PROJECT No. 1656263.1000.1001

FEDERAL INFORMATION REQUEST T(3)-08 – COMPILED RESPONSE DOCUMENTS AND RELEVANT COMMUNICATIONS

HAMMOND REEF GOLD PROJECT – TAILINGS MANAGEMENT FACILITY, ADDITIONAL 3D GROUNDWATER MODELLING

PROJECT NO. 1656263	CONTROL 0001	REV. 0.0	FIGURE 3
------------------------	-----------------	-------------	--------------------

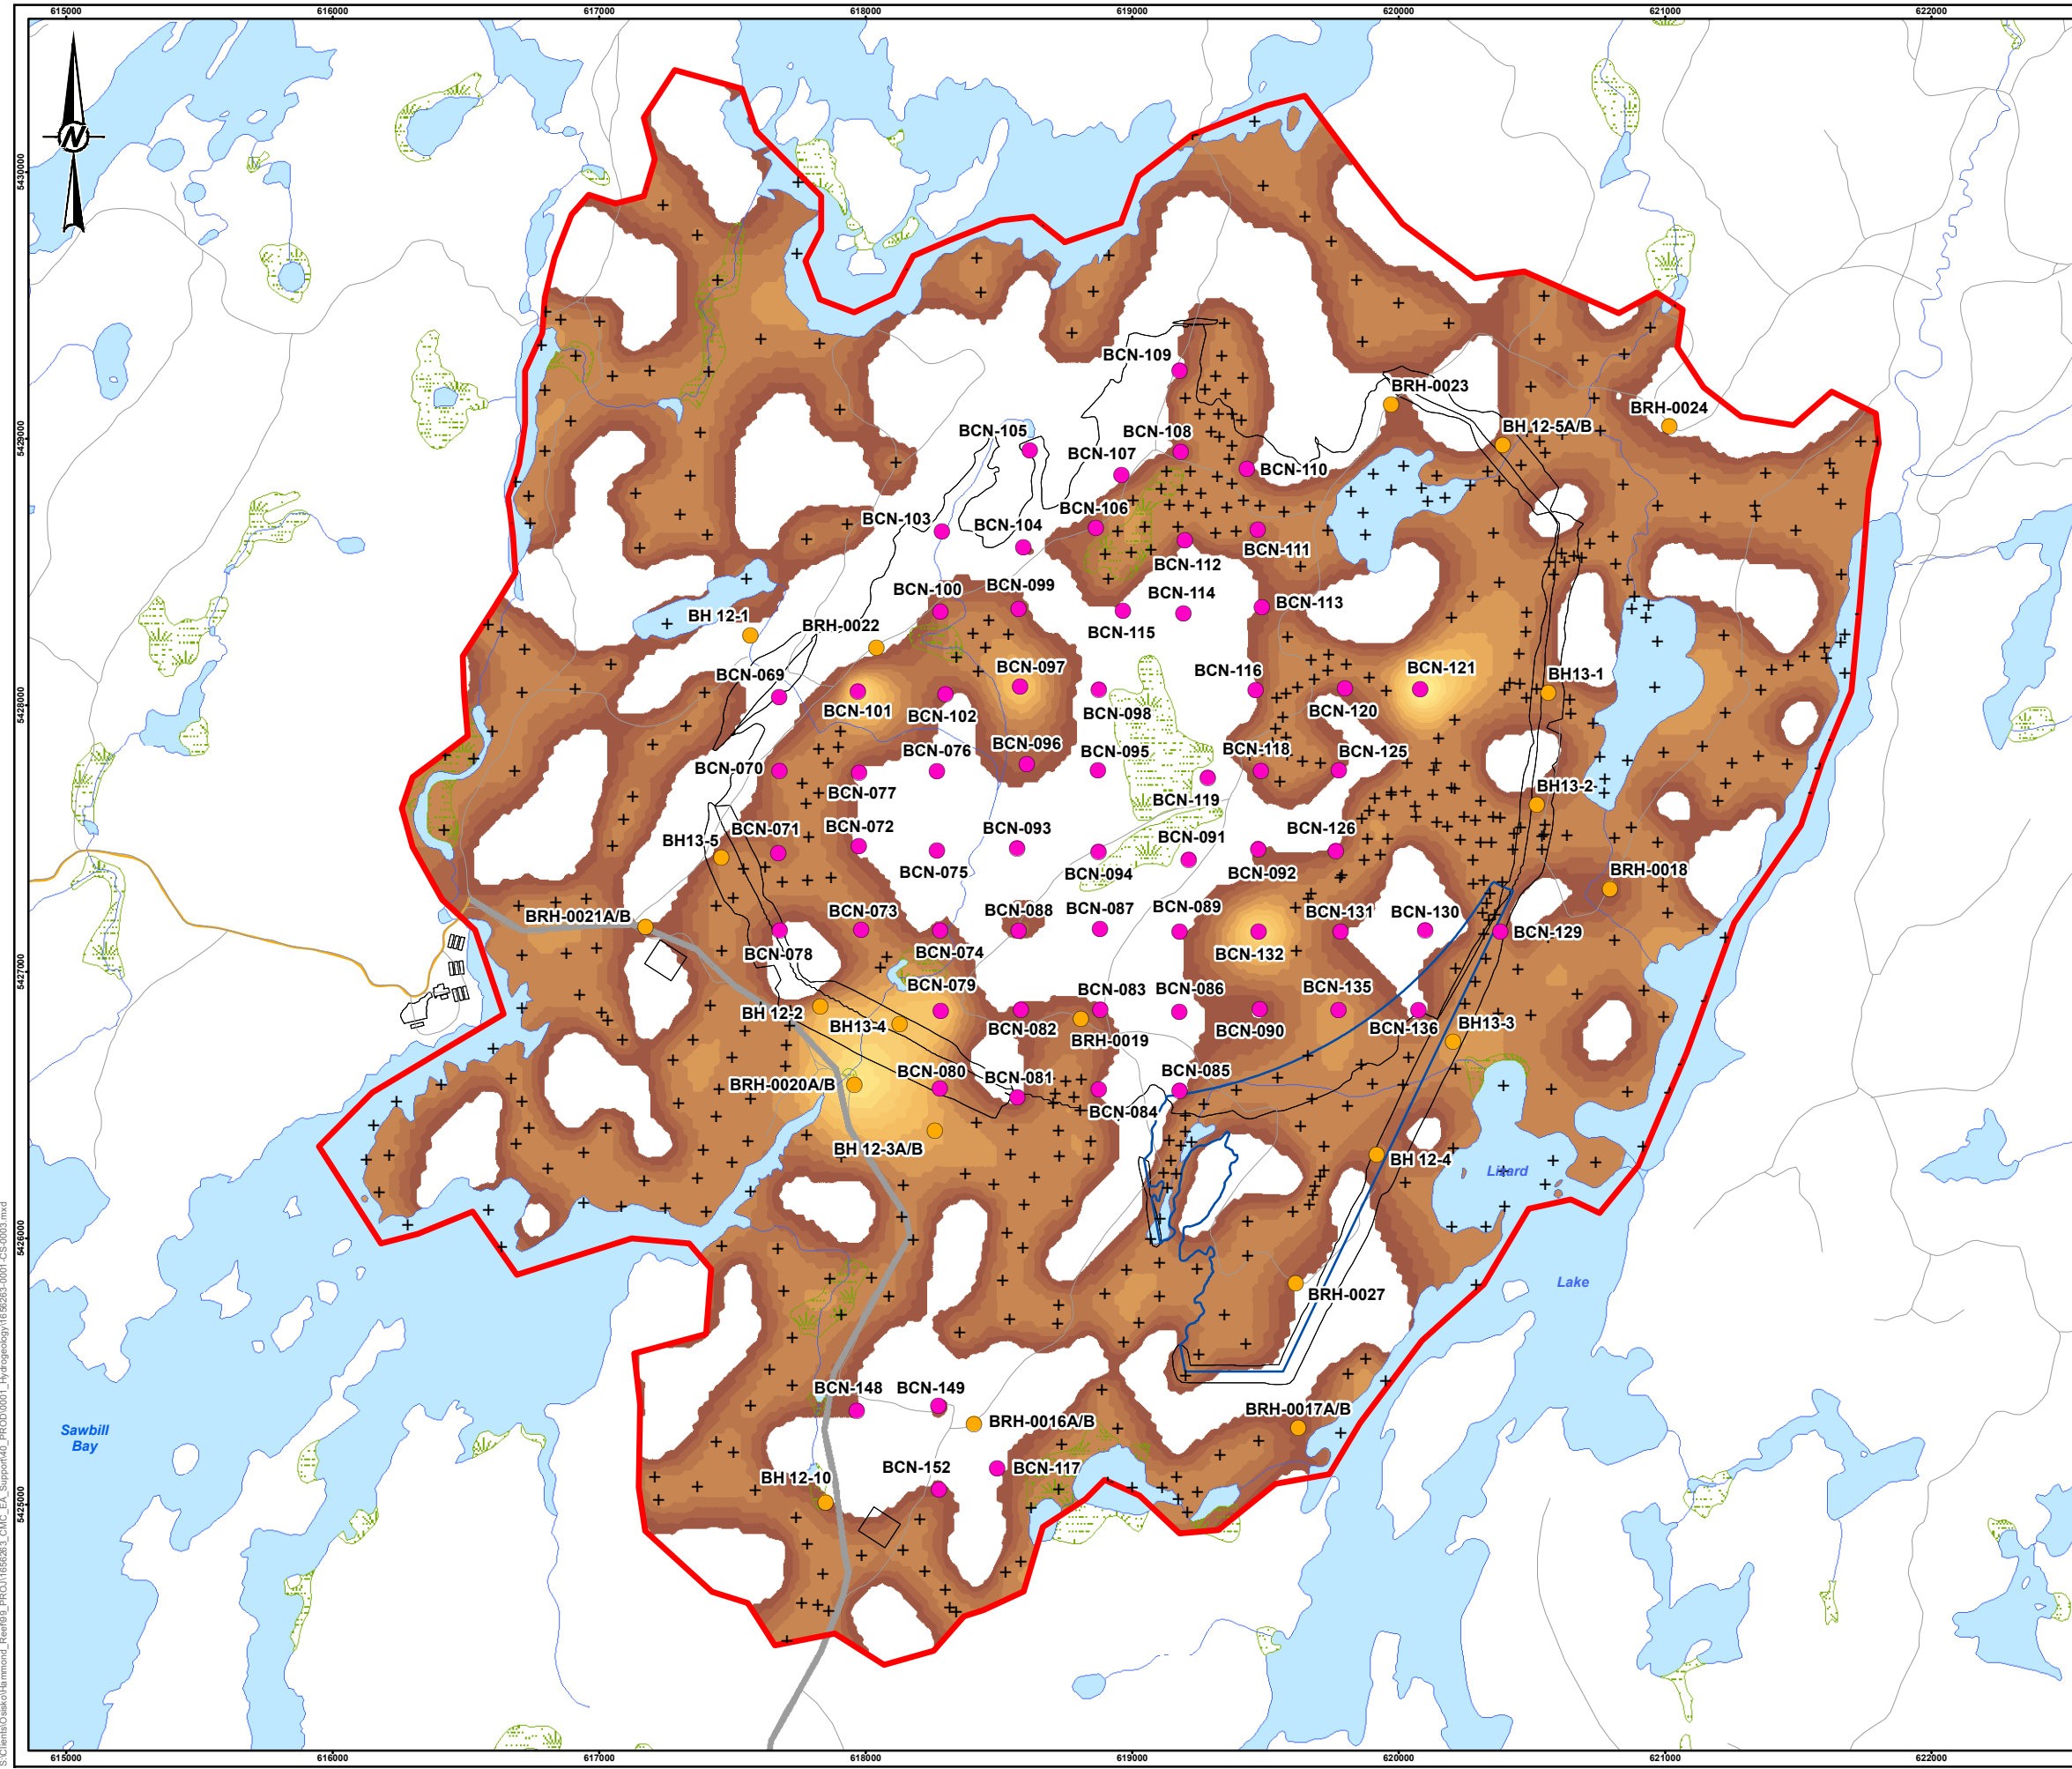
opinion that the bedrock valleys may be more continuous than suggested in Figure 3 (Golder Associates, 2016b); some of the wider bedrock troughs are more continuous and may be deeper than modeled, as demonstrated by the many NNE-SSW trending valleys and lakes in the area (e.g., Lizard Lake). These buried bedrock troughs are somewhat under-represented in the data set as their wide and flat valley bottoms are less accessible due to the presence of peat bogs (see Figure 2). Also, the delineation of the surficial mapped polygons from Stea's (2010) map would require many more data points than the number of boreholes and therefore would bias the interpolation to that dataset. NRCan proposed that the methodology would provide a more conservative interpolation if more "dummy points" were used to ensure continuity in potentially significant buried valleys.

The sediment thickness was re-interpolated (Figure 3) using more "dummy points" in the updated Technical Memorandum (Golder Associates, 2016a) with the result of having more continuity in potential buried valleys.
